PLAN REVIEW SHEET

Petition: 2014-117 Telephone: 704-353-001

Fairview Plaza JLC, LLC Email: bhorton@charlottenc.gov
Attachments: Waiting Pad Detail

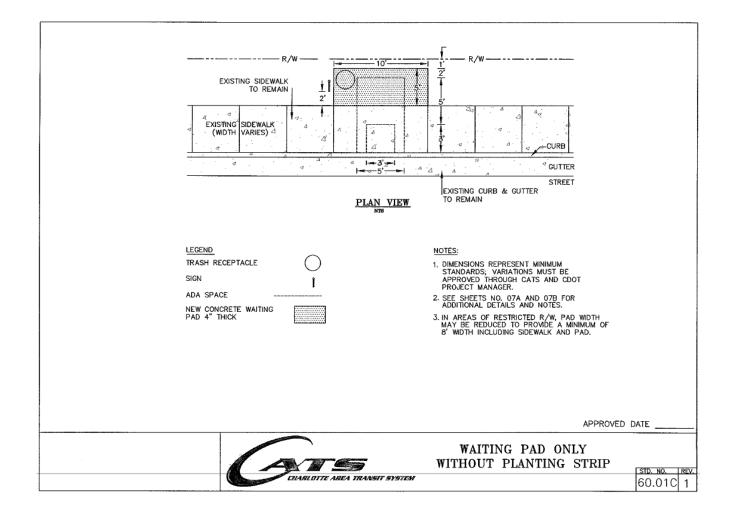
The Petitioner is requested to provide and construct a concrete pad for the existing bus stop along Park South Drive. Below is an image of the standard detail (60.01C) for the requested concrete pad. The site plan may either show the conceptual location of the improved bus stop on Park South Drive, or alternatively, include a development note to locate the bus stop pad during the development review and permitting process.
